Terex Utilities

SAFETY NOTICE

SN728

SUBJECT: Platform Tilt Controller

Figure 1. Remove Leveling Link Cover to inspect the power wire for the Level Sensor

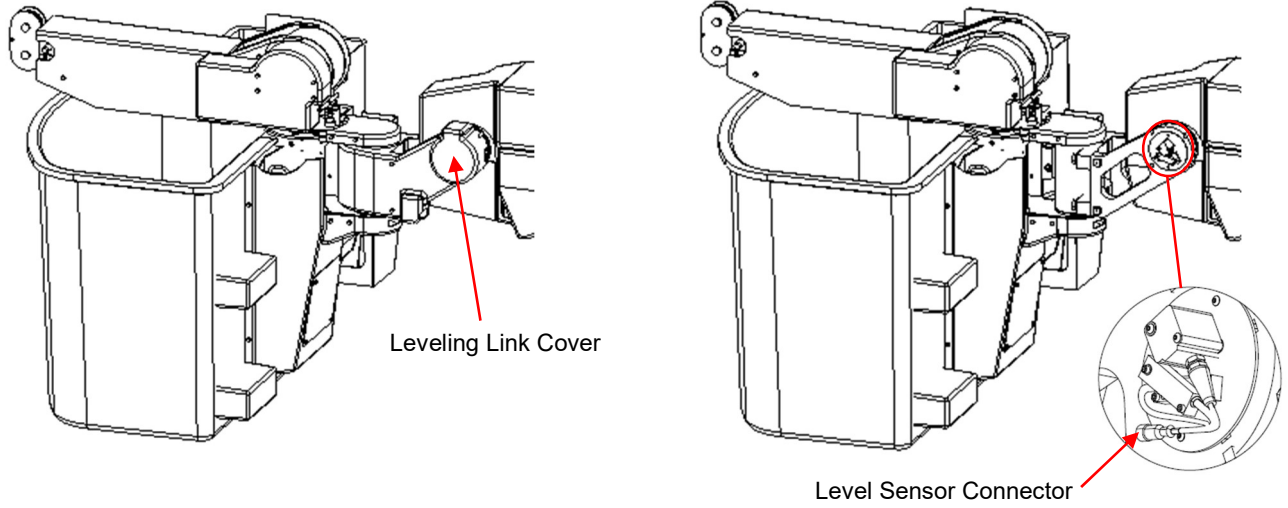
3. Remove needed covers to verify that the power wire for the Level Sensor is securely connected to the sensor, is undamaged along its length, and routed so it cannot be pinched, see Figures 1 through 3 at the end of this bulletin as reference. Repair, replace, or re-route the power wire as required.
